OUR TOWN HALL
MANCHESTER CITY COUNCIL
Amendments to Size of Stone Components
March 2023

Issue Details				
DOCUMENT TITLE	DOCUMENT REVISION	ISSUED FOR	ISSUE DATE	REVIEWD BY
Amendments to size of stone components

Figure 1 Extract from the issue drawings for Princess Street showing the proposed stone variation (text highlighted in pink). For full details see supporting drawings

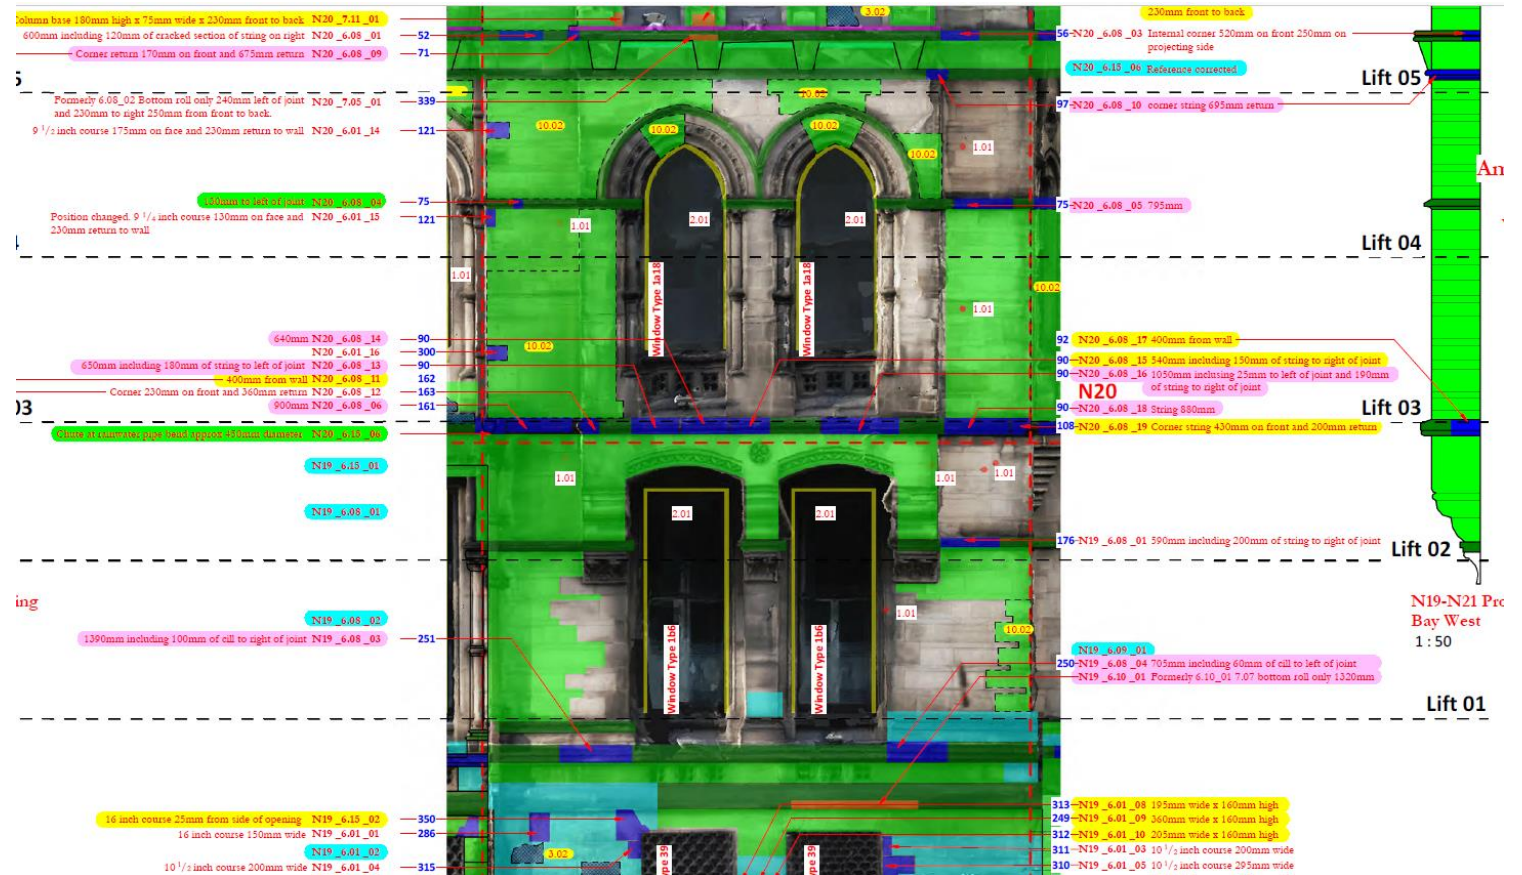
The exact number of stones that will vary in size is not known at this stage and this document is intended to present the issue and the proposed resolution in principle. The strategy is presented alongside the proposed amendments to Princess Street and Lloyd Street which will allow any changes to be recorded as a physical record and submitted as part of condition 11u. It is important to note that not all of those stones identified in the supporting documentation will require varying size as this document is intended to agree the principle.

- Any change to the size of existing stones will only take place where the matching stone size is not available
- Where additional joints have to be introduced to string courses or hood moulds the joints should be a minimum of 75mm from joints in the ashlar stone or voussoirs above and below. In general, the joint spacing should be greater than this absolute minimum with a preferred spacing of 100 to 150mm.
- Where a row of replacement components occurs, such as several string course stones, the total length should be

considered with the space filled with the minimum number of replacement components to the maximum length available. In these instances, the length of the replacement components should be varied.

- In all instances where it is proposed to vary the length of replacement components the drawings for these components should be re-issued showing the location of the perp joints above and below and the location of other features such as window reveals in relation to these components so that the joint spacing can be assessed and agreed.

- Where a row of replacement components occurs, an amended drawing should be issued showing the row of components with the proposed new joint arrangement in relation to perp joints above and below and other features such as window reveals.
